ALERT SERVICE BULLETIN

SUBJECT: AIRWORTHINESS LIMITATIONS - Time Change Items

Change of Life Limits
ATA: 04

Revision No.	Date of issue
Revision 0	2017-04-27

Main Rotor Head (62-21)
Figure 1

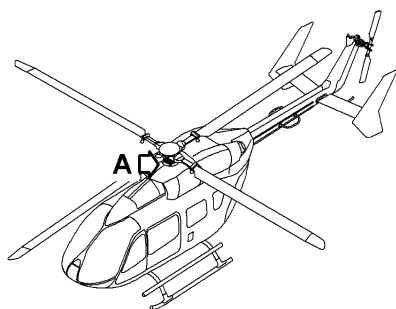
Main rotor head (62-21)

Disposition	Part number	Life limit entry	
		old	new
Nut	B622M1003201	83000 Flights or 12769 Fh	65800 Flights (10123 Fh) (2)(3)
Quadruple nut upper	B622M1004201	67000 Flights or 10308 Fh	60000 Flights (9230 Fh) (2)(3)
Quadruple nut lower	B622M1005201	67000 Flights or 10308 Fh	60000 Flights (9230 Fh) (2)(3)
Bolt	B622M1006201	35000 Flights or 5385 Fh	31200 Flights (4800 Fh) (2)(3)
Bolt	B622M1007201	35000 Flights or 5385 Fh	31200 Flights (4800 Fh) (2)(3)
Inner sleeve	B622M1009201 (1)	15000 Fh	13300 Fh
(1) The inner sleeve is only replaceable as an assy P/N B622M1009101. (2) The number of flights is to be considered equal to the number of landings (ground contacts). (3) For the calculation of the life limit the number of flights has priority. If the number of flights is not known, the flight hours in brackets must be used.

Swash plate (62-32)
Figure 2

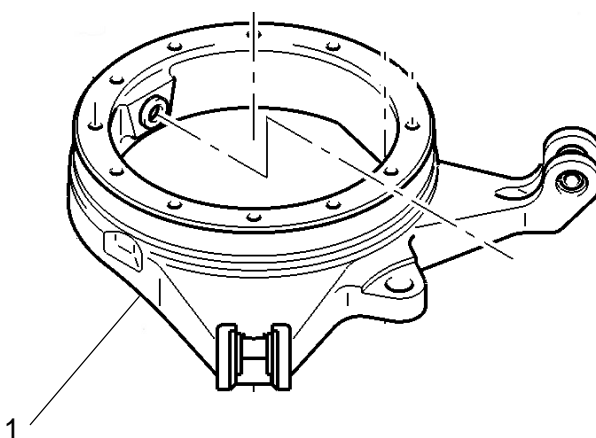
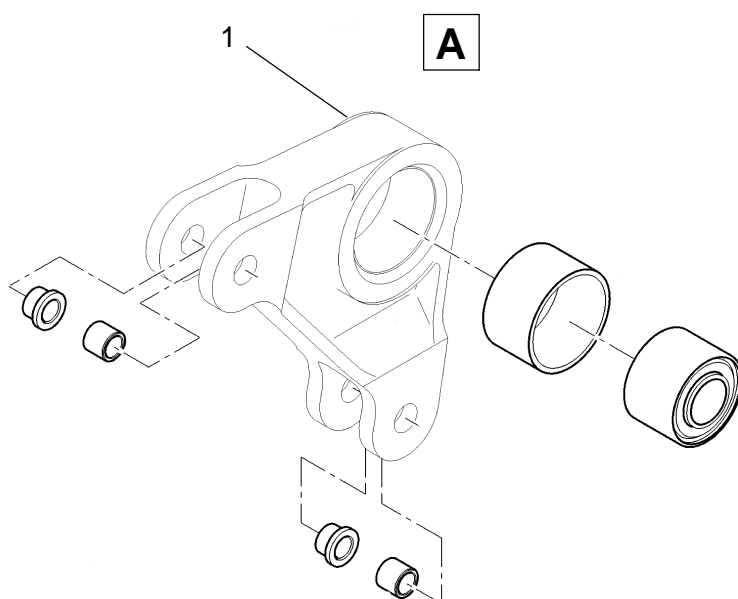
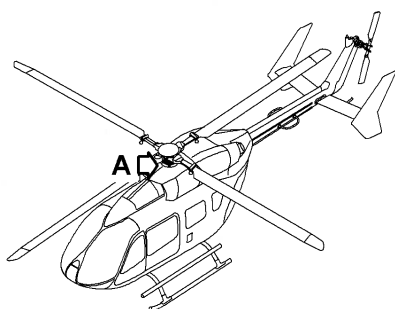
Swash plate (62-32)

Disposition	Part number	Life limit entry	
		old	new
Control ring assy	B623M2001101	30000 Fh	27600 Fh

Rotor flight controls (67-10)
Figure 3

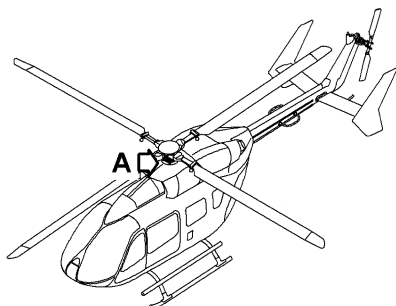
Rotor Flight Controls (67-10)

Disposition	Part number	Life limit entry	
		old	new
Bellcrank-K (collective)	B670M7021201 (1)	-	21500 Fh
(1) The bellcrank-K (collective) is only replaceable as an assy P/N B670M7021101 / B670M7021102.

Cyclic controls (67-12)
Figure 4

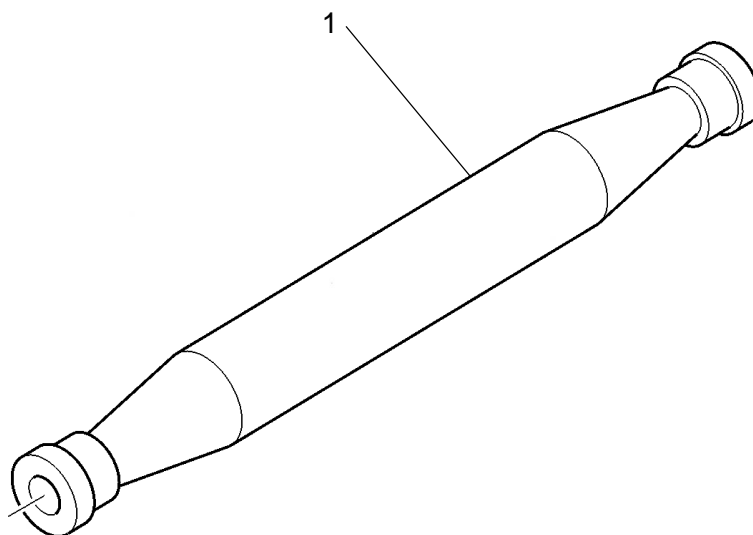
Cyclic Controls (67-12)

Disposition	Part number	Life limit entry	
		old	new
Control Rod Tube	B291M1015201	-	30000 Fh

Upper Controls (67-17)
Figure 5

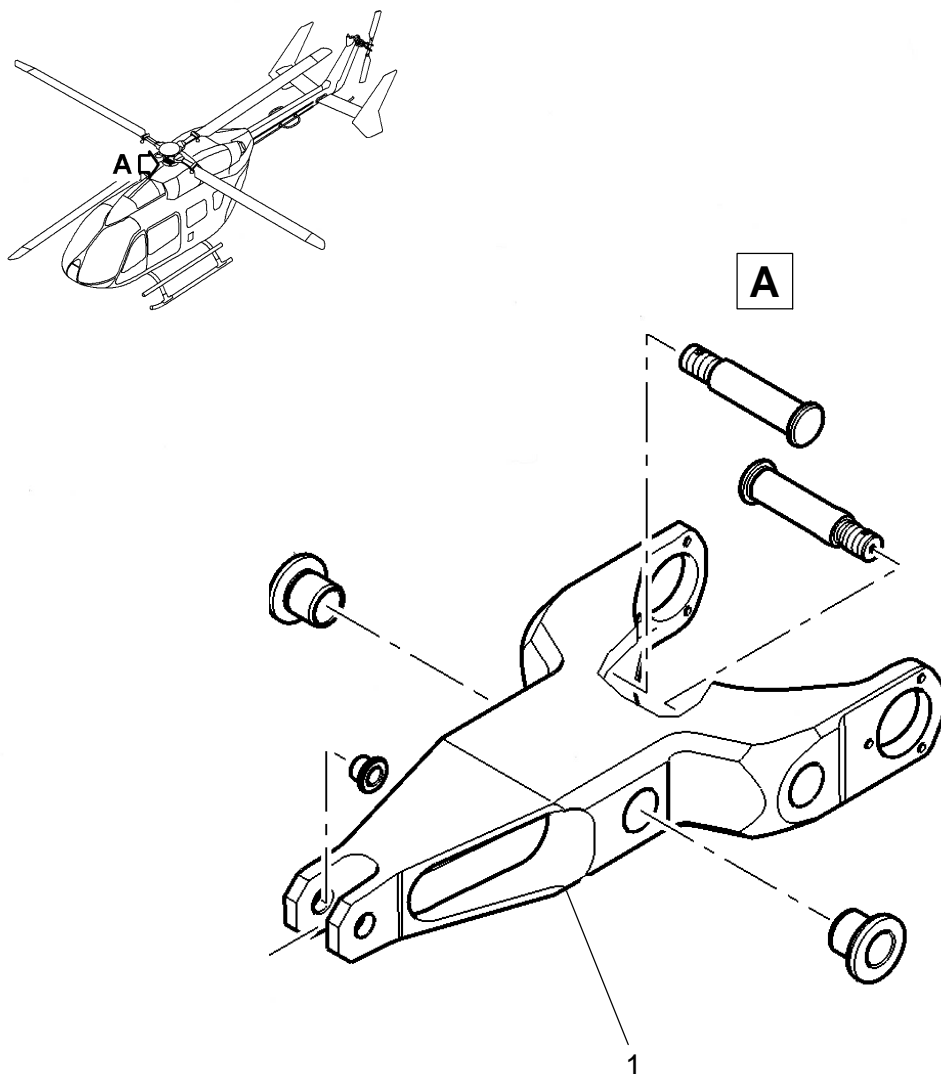
Upper Controls (67-17)

Disposition	Part number	Life limit entry	
		old	new
Forked Lever	B671M7007201 B671M7007205	-	22500 Fh (1)
(1) Next higher assembly: Forked Lever Assy B671M7018102.
